PREPARED FOR THE URBAN DESIGN COMMISSION AND PLAN COMMISSION

Project Address: 330 East Wilson Street
Application Type: Demolition Permit and Conditional Use
Legistar File ID #: [33909](#)
Prepared By: Heather Stouder, AICP, Planning Division
Report Includes Comments from other City Agencies, as noted

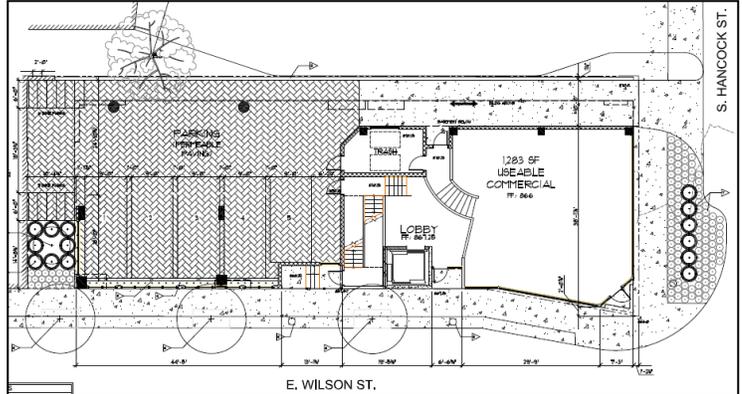
The revised proposal accommodates a similar program within a similar building as was discussed in the staff report dated June 11, 2014 and subsequently the addendum dated July 28, both of which are included for reference. Notably, the under-building parking area has been modified to allow space for a small commercial space along the western half of the building, instead of the shallow display area that had been proposed as a screen for the parking area behind it. This change addresses a major staff concern, and allows for the removal of Condition No. 1 from the June 11 staff report.

The revised site plan now includes four parking stalls instead of five, and an additional 645 square foot commercial space, complete with a detailed floor plan showing an office layout. The applicant has indicated that this space will be utilized for their office space, and while it may only be viable as an office space for small businesses or non-profit organizations over time, zoning would allow for it to be utilized for a variety of uses.

October 6 Submittal UDC/PC Submittal

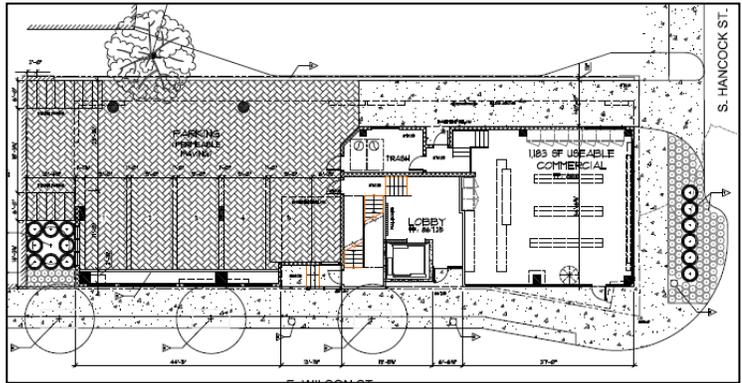
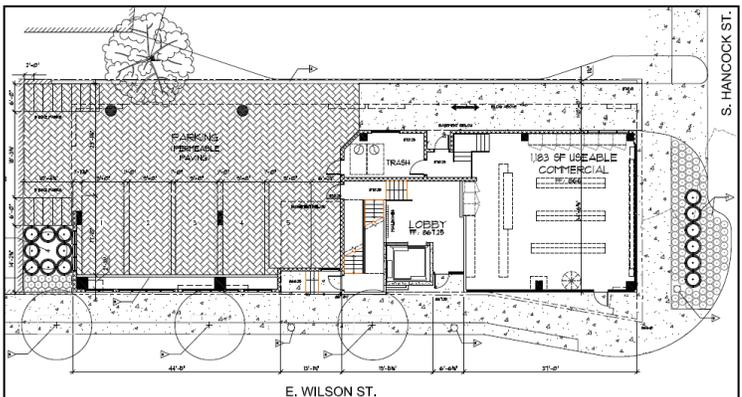
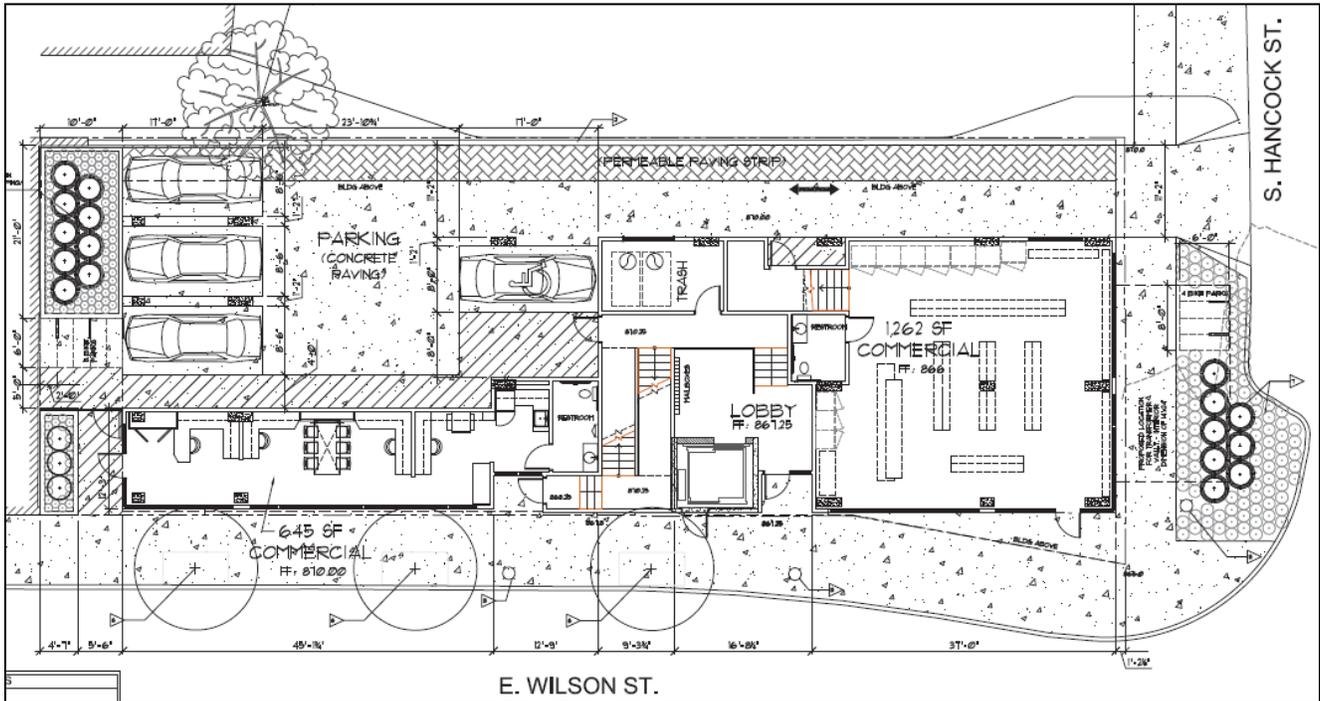
As reflected in the renderings on the following page, other relatively small changes in the most recent submittal can be summarized as follows:

Stair tower revisions – In the October 6 revisions, the stair tower is now a grey stone, and includes an inset panel of cedar lap siding proposed to be painted in various shades of blue. The metal and a set of windows overlap the tower element in the area of the stairway, replacing what had been vertical glass within the stone tower element itself. The top of the stair tower is wider along East Wilson Street, and while the vestibule leading from the tower to the outdoor open space on the rooftop is smaller, revisions to this area still need to be made to meet Zoning requirements. The UDC has discussed the stair tower in each meeting where this project has been reviewed, and staff looks forward to further input from the UDC on this significant architectural piece.

Building color – The proposed color of the metal panels is now a very light grey, rather than white, and it has inset areas with blue fiber cement ship lap siding on all sides of the building. Staff maintains that a contemporary brick building would be preferable in this location (see Analysis section). However, if it is approved as a metal building, staff would like UDC feedback on the proposed color scheme.
